SERVICE ADVISORY # 15-227**Summerland Mini Fuse**

It has been determined the below listed vehicles were manufactured with an undersized 15 amp fuse placed in the battery charging circuit which should have a 30 amp fuse. The circuit is wired and rated for 30 amp capacity. This advisory explains how to correct.

Model and Serial Numbers Included: 2015 Summerland Mini 1400FD, 1600BH, 1700FQ, 1800BH

Fig. 1

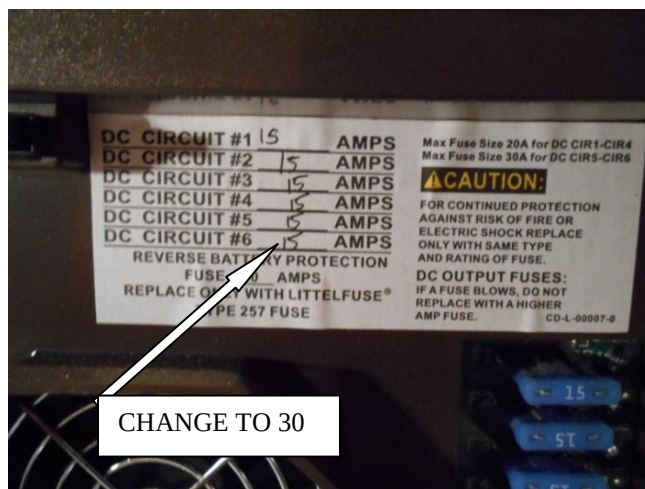
Step 2 Locate the fuse panel in the unit. Remove the 15 amp fuse from the number 6 location of the fuse panel. Replace the fuse with a 30 amp fuse. Change the noted fuse size of position 6 on the information label from 15 to 30.
